SAM G53 Series Family Silicon Errata and Data Sheet Clarification

Data Sheet Clarifications

5. Module: Transmitter Operations

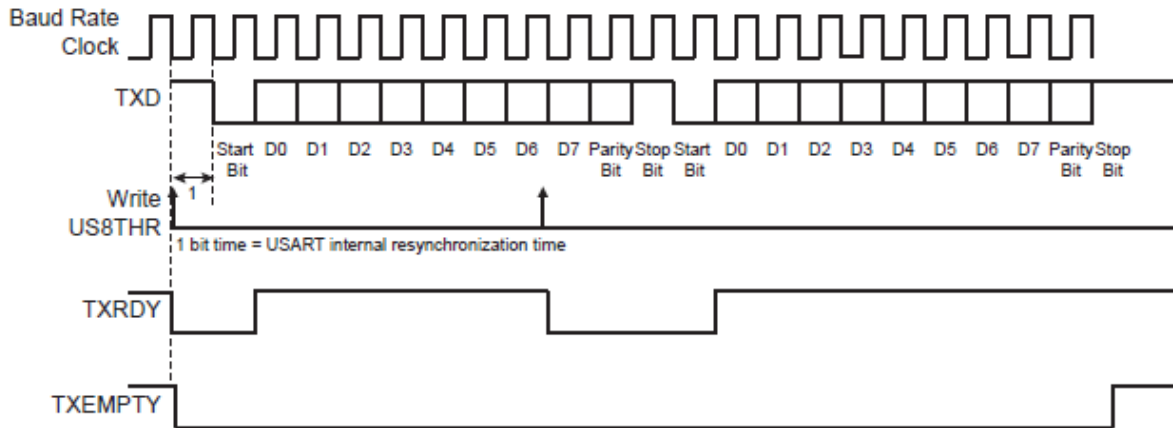
Figure 33-6 is incorrect, and the corrected figure is as follows:
